OXFORDSHIRE COUNTY COUNCIL'S RESPONSE TO CONSULTATION ON THE FOLLOWING DEVELOPMENT PROPOSAL

Application no: 23/00517/F

Proposal: Redevelopment of the site to include the demolition of existing buildings and development of new accommodation across 5 buildings for employment uses (Class E(g)(ii) and (iii)) plus ancillary amenity building, outdoor amenity space, car parking, cycle parking, landscaping and associated works

Location: New Science Park Land West Of The Junction With The Boulevard, Oxford Airport, Langford Lane, Kidlington

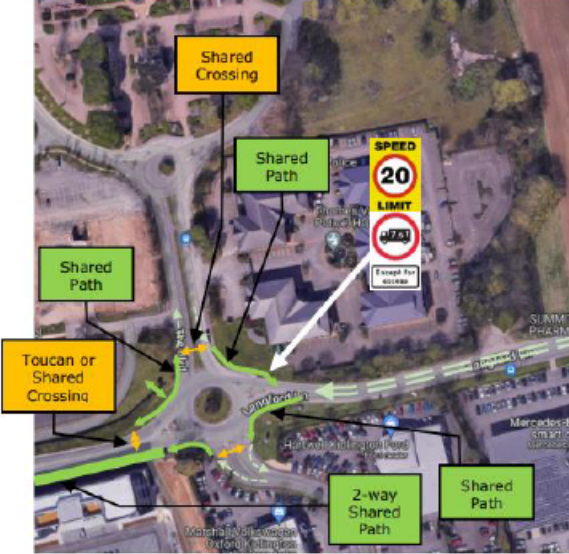
Figure 3 in the TA usefully illustrates possible cycle improvements for Langford Lane (part reproduced below). The measures at The Boulevard roundabout which are feasible and have not yet been implemented are considered necessary for this proposal and are therefore required as part of the S278 works.

The 2-way Shared Path is in place to the west of the roundabout, so an improved connection to this facility from the site is required. This will be a formal crossing, i.e. a Toucan or parallel crossing, at a suitable location to be determined and verified by Road Safety Audit. Similarly, an appropriate crossing of The Boulevard is necessary for cyclists from the site to be able to bypass the roundabout and for pedestrians to cross to the bus stop. Footways around the four corners of the junction should be widened for shared use and tie-in with the crossing points, as well as providing a clear transition between on- and off-road cycling as highlighted in the LCWIP.

Changes to the Oxford Motor Park arm are not required as this road is outside of the adopted highway boundary.

- A formal (Toucan or parallel) crossing on the western Langford Lane arm of the roundabout junction with The Boulevard
- An informal crossing of The Boulevard, just north of the roundabout junction with Langford Lane
- Widening of the footways to 3m around the Langford Lane / The Boulevard roundabout and conversion to shared use, including improved cycling transitions on and off the carriageway
